Operator: BONANZA CREEK ENERGY OPERATING COMPANY

Location Name: State Antelope14-24 PAD

Inspection: 696304999

Exhibit A

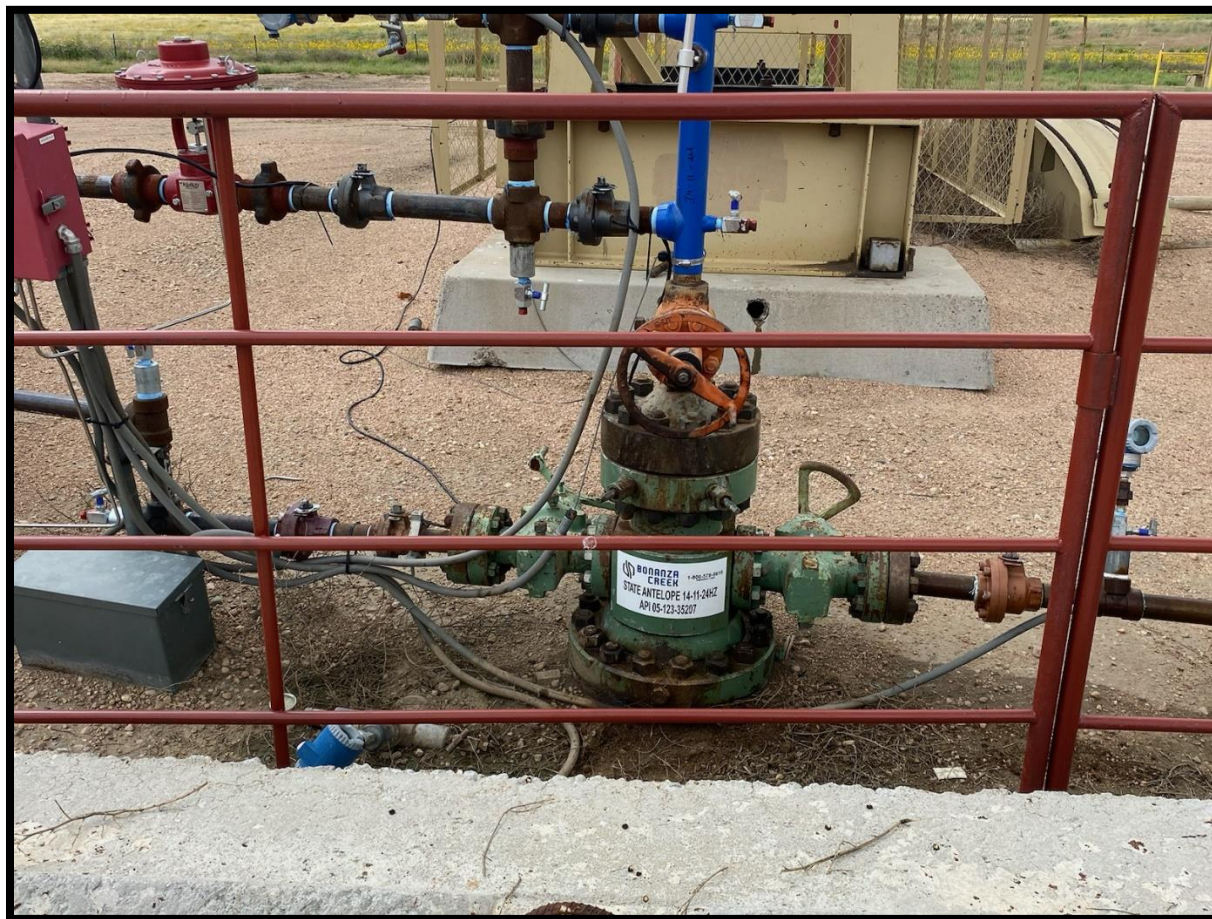
CA: 14-11-24HZ missing Wellhead sign, see photos. Install sign to comply with Rule 605.d.

CA Resolution: Wellhead sign has been installed comply with Rule 605.d.
